Service Letter No. 330

SUBJECT: South Wind Service Bulletin dated February 22, 1960

MODEL AFFECTED: PA-23 Apaches Equipped with South Wind Heaters  
Model D-12, Serial Nos. 1272 to 1321 inclusive  
Model B-12, Serial Nos. 1663 to 1722 inclusive

SUBJECT: Combustion Blower Wheel (P/N G- 484046) Used in the 940 Light Aircraft Heaters

## MODEL 940 COMBUSTION BLOWER WHEEL

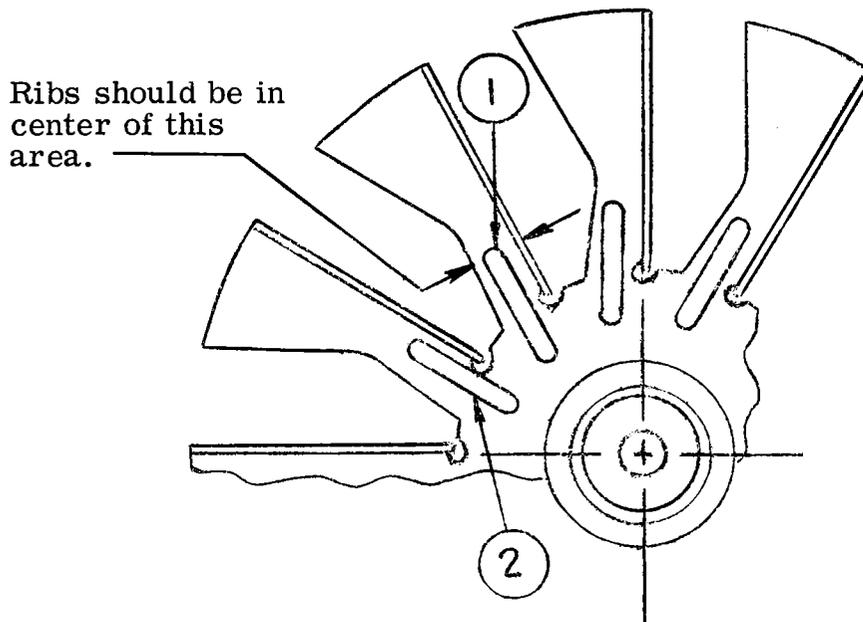
Item 1 of the drawing indicates the proper location of the strengthening rib in the center of the blades.

Item 2 of the drawing indicates the location of the strengthening ribs on the blower wheels which are considered to be defective.

In addition to the rib being too close to the fold of the blade, inspection will in most cases reveal the presence of a crack in the portion of the fold nearest the hub of the wheel. After operation, an additional crack may develop in the radius of the fold in a direction generally perpendicular to the hub, and continued operation and the associated vibration after this second crack develops will lead to the breaking off of the particular blade.

In order to expedite this replacement, we have arranged an exchange program with South Wind Division of Stewart-Warner for the replacement of the subject blower wheels affected. We recommend these blower wheels be replaced no later than the next 100 hour inspection. The new blower wheels may be ordered from your Piper distributor under part number 751 776.

Please check your spare parts stock. We will replace, at no cost, any defective blower wheel, P/N G- 484046, returned to our factory for replacement.
